## LAKE EOLA HEIGHTS TOWNHOME PD 115 E CONCORD STREET

### Changes to the Staff Report:

# LAKE EOLA HEIGHTS TOWNHOMES PD

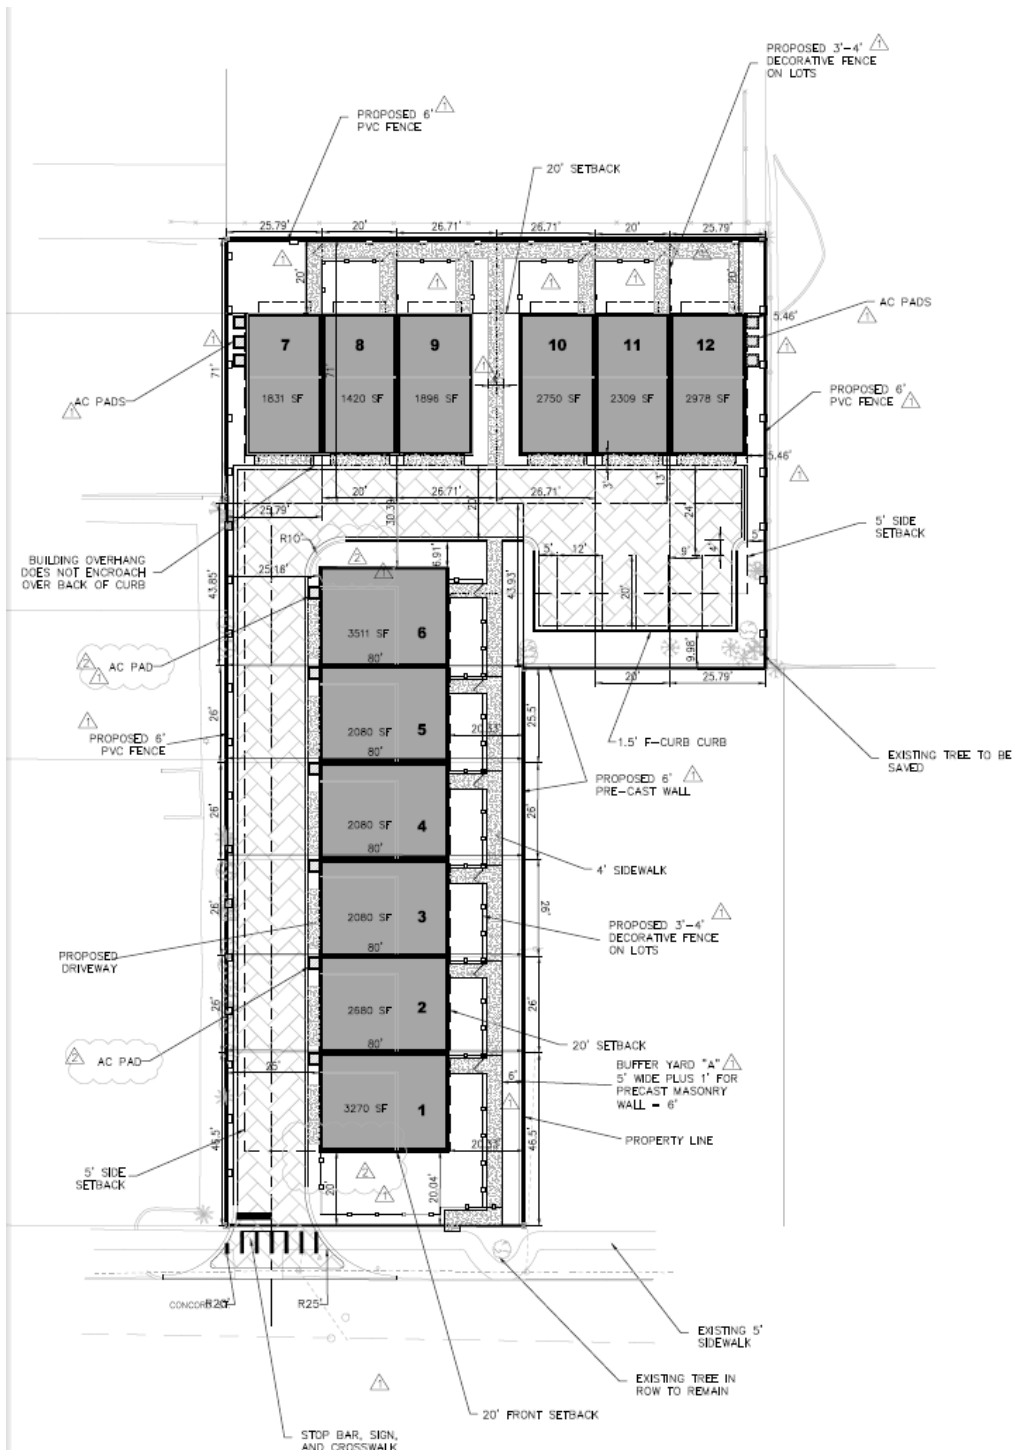
Page 15, Land Development (Added Condition) :

19. A/C Units. The proposed A/C units shall be relocated outside of the front yard setback, between E. Concord Street and the front façade, per LDC standards. (per the attached revised site plan)
